ADDENDUM 002

Transfer Station Pump Station

UPGRADES TO TRANSFER SEWAGE PUMP STATION

ADDENDUM NO. 2 – June 23, 2021

1. I have snipped the detail below from the Drawings for the Upgrades to Transfer Sewage Pump Station Project, Sheet C-3.03, "Precast Concrete Manhole Detail" which is currently out to bid. It cannot be bid by a sub-contractor as written:

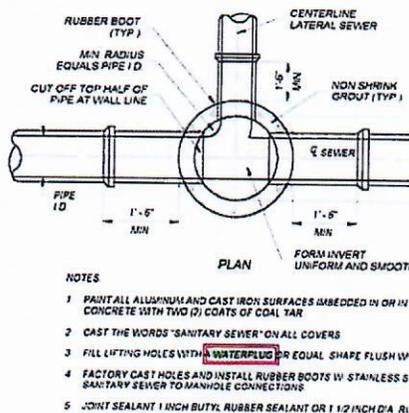
The product as specified does not exist or is not available as it is currently named and described.

- The "Waterplug" brand product was discontinued.

Consequently, there is no product reference standard for contractors to base their bid.

The acceptable equivalent and locally available product for your specified need manufactured by UGL are "DRYLOK FastPlug Hydraulic Cement". I have attached information on this product.

I respectfully request you consider DRYLOK FastPlug Hydraulic Cement as an "or equal" and include in an upcoming Addendum.

Response: DRYLOK FastPlug Hydraulic Cement will be considered as an approved equal.
